SERVICE LETTER

No. 665A

Rotator Type Intake Valves -- reference Lycoming Service Instruction No. 1280A dated September 28, 1973, reproduced on reverse side.

Service Instruction No. 1280A
(Supersedes Service Instruction No. 1280)
Engineering Aspects are
FAA (DEER) Approved

Rotator Intake Valve Components

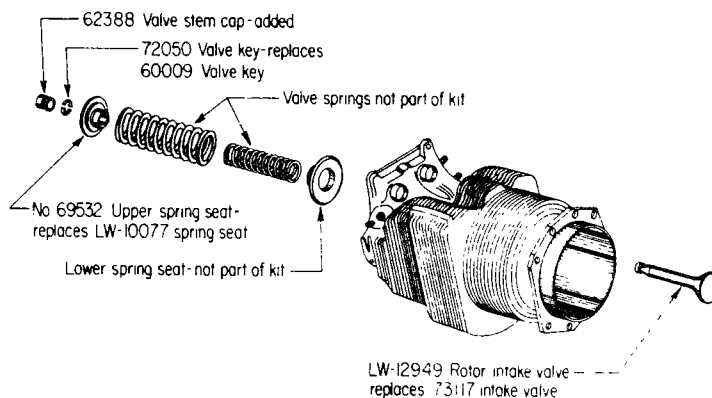
In order to improve valve seating and minimize compression loss at the intake valve seat, a new intake valve, incorporating a rotator cap is available for installation in applicable aircraft engines now in service. This rotator valve, LW-12949 and its associated parts replace the conventional intake valve, 73117 that has been used in these engines.

Kit No. LW-13292, Rotator Valve Replacement for one cylinder consists of:

| 1 no. LW-12949 | Intake Valve (replaces 73117 intake valve) |
| 1 no. 69532 | Upper Spring Seat (replaces LW-10077 spring seat) |
| 2 no. 72050 | Valve Key (replaces 60009 valve key) |
| 1 no. 62388 | Valve Stem Cap (added part) |
